HISTORIC AND DESIGN REVIEW COMMISSION

HDRC CASE NO: 2019-343
ADDRESS: 414 DONALDSON AVE
LEGAL DESCRIPTION: NCB 1932 BLK 39 LOT 26 AND 27
ZONING: R-6,H
CITY COUNCIL DIST.: 7
DISTRICT: Monticello Park Historic District
APPLICANT: KKW Donaldson
OWNER: San Antonio San Antonio/KKW Donaldson
TYPE OF WORK: Window replacement, painting brick, replace siding
APPLICATION RECEIVED: May 22, 2019
60-DAY REVIEW: July 21, 2019
CASE MANAGER: Stephanie Phillips
REQUEST:

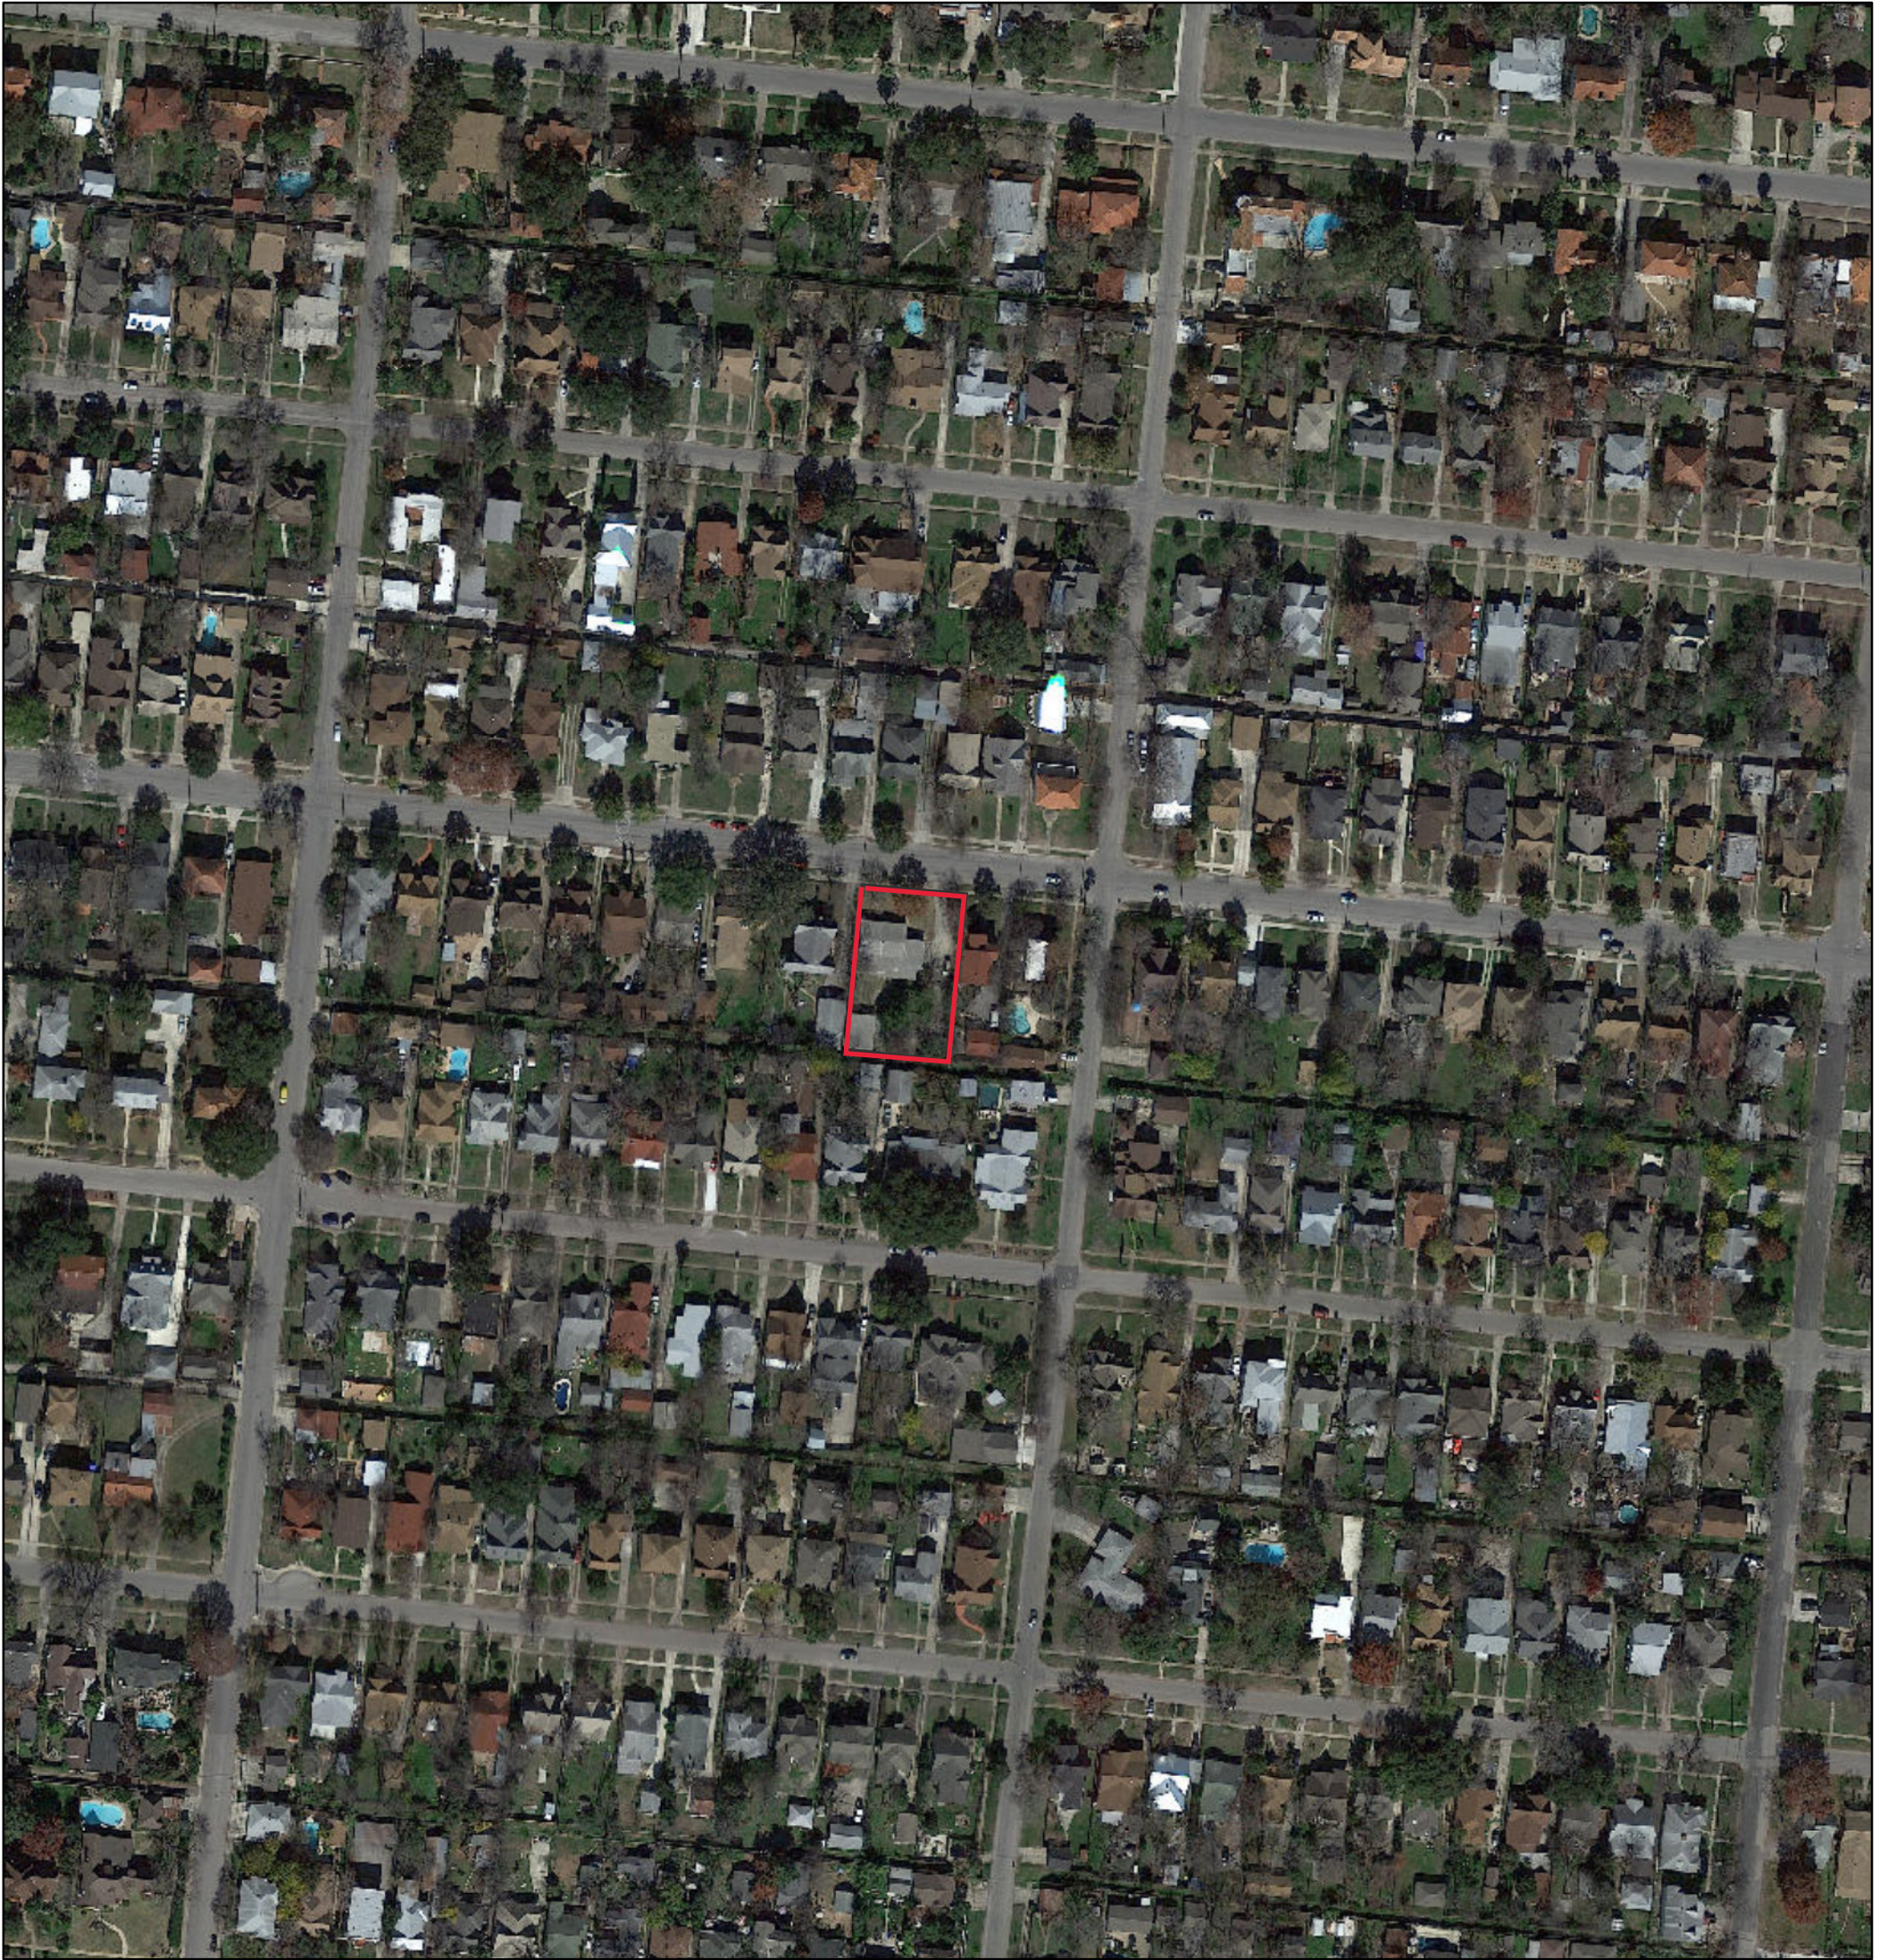
- d. **WINDOW REPLACEMENT** – The applicant has proposed to replace an existing rectangular aluminum picture window on the front façade with a new vinyl window. The new window will feature a modified size and be square in proportion. According to the Guidelines, when windows are deteriorated beyond repair and necessitate replacement, new windows should match the size, configuration, proportion, and detailing of the original. Staff generally finds that replacement is appropriate, but finds the proposed size modification to be inconsistent with the Guidelines. Staff finds that the existing opening size should be retained.

- e. WINDOW INSTALLATION – The applicant has proposed to install a new window on the front façade. The window is to match the size, material, and configuration of the proposed replacement window noted in finding d. The new window will be visible from the public right-of-way. Staff generally finds the location appropriate, but does not find a square window to be appropriate. Staff finds that a rectangular window that matches the existing size of the adjacent window in finding d be installed to add balance and maintain the original proportionality of the windows.

Item 3, Staff recommends approval of the window replacement based on finding d with the following stipulation:

- i. That the window size matches the existing opening and configuration. The applicant is required to submit an updated window specification to staff with dimensions for review and approval.

Item 4, Staff recommends approval of the installation of a new window opening on the front façade based on finding e with the following stipulation:

- i. That the window size matches the existing opening on the front façade as noted in finding d. The applicant is required to submit an updated window specification to staff with dimensions for review and approval.

Paint exterior (Minor Alteration, Continued), Methodology

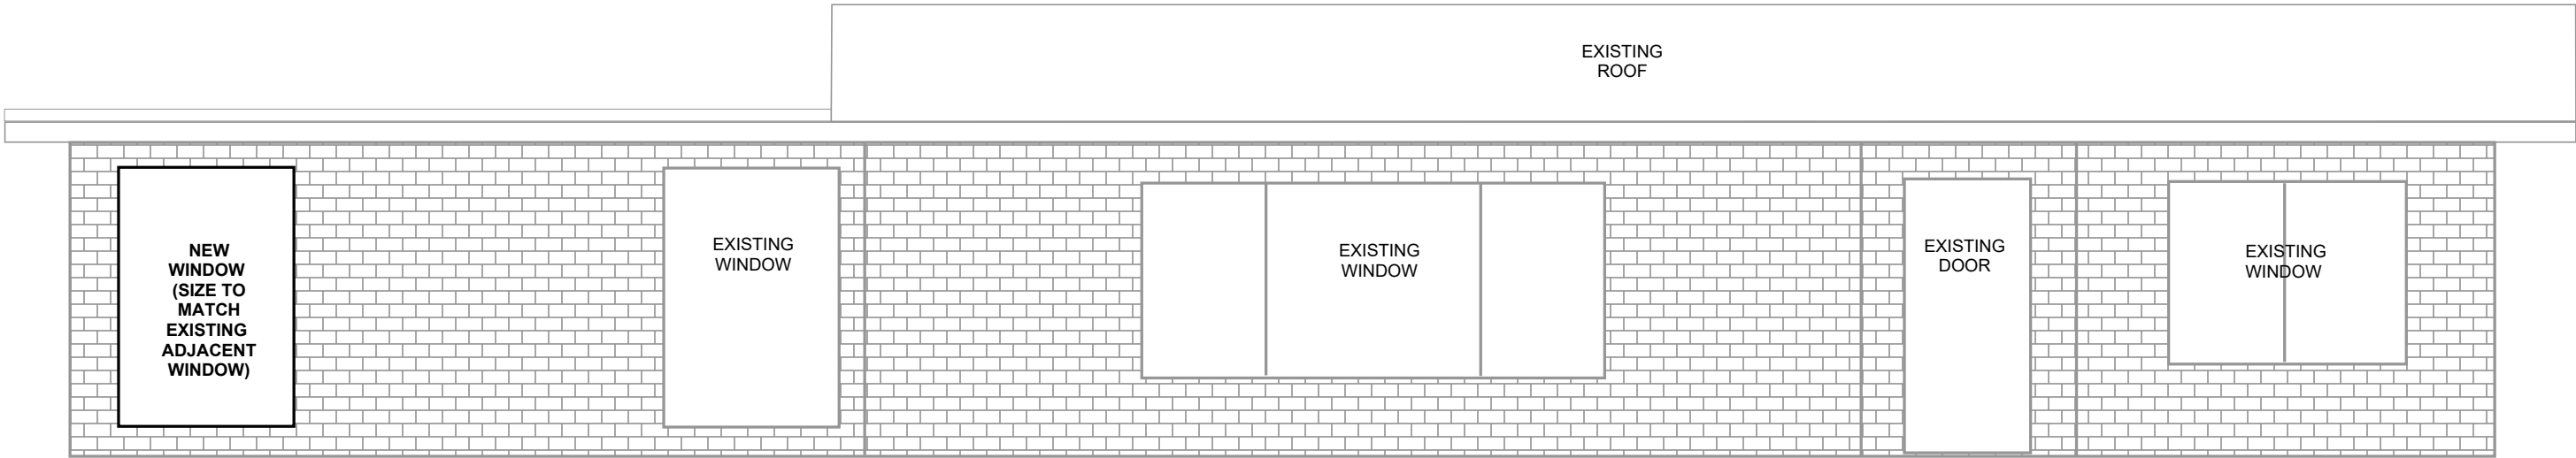
- g. BRICK PAINTING – The applicant is requesting approval to paint the brick façade of the structure. The original brick, a rusty red color, is exposed. According to the Secretary of the Interior’s Standards for Rehabilitation, historically unpainted brick should not be painted. Brick structures built prior to the 1870s were largely constructed of handmade bricks, which were generally softer, more porous, and weaker than bricks made at the turn of the 20th century. These handmade bricks were frequently painted or coated because the strength of the brick was insufficient without a coating for stabilization. However, as machine-made bricks became the norm during the latter half of the 19th century, bricks became inherently stronger and did not require paint or coatings for protection and strength. These bricks commonly featured harder “dress” surfaces, which were meant to face the exterior of the structure and remain unpainted. 414 Donaldson was constructed in the early 1950s and was historically unpainted. Painting historically unpainted brick on structures of this era can lead to trapped water in the porous material, eventually destroying the brick due to the damaging effects of water infiltration and freeze-thaw cycles. Unpainted brick of this era is inherently high strength and low-maintenance on its own. Once these structures are painted, consistent repainting is required to maintain the aesthetics of the brick. Per the Guidelines for Exterior Maintenance and Alterations, 2.B., surfaces that were historically unpainted should not be painted. Staff does not find the painting of the façade to be appropriate.

Item 6, Staff does not recommend approval of painting the exterior brick based on finding g.
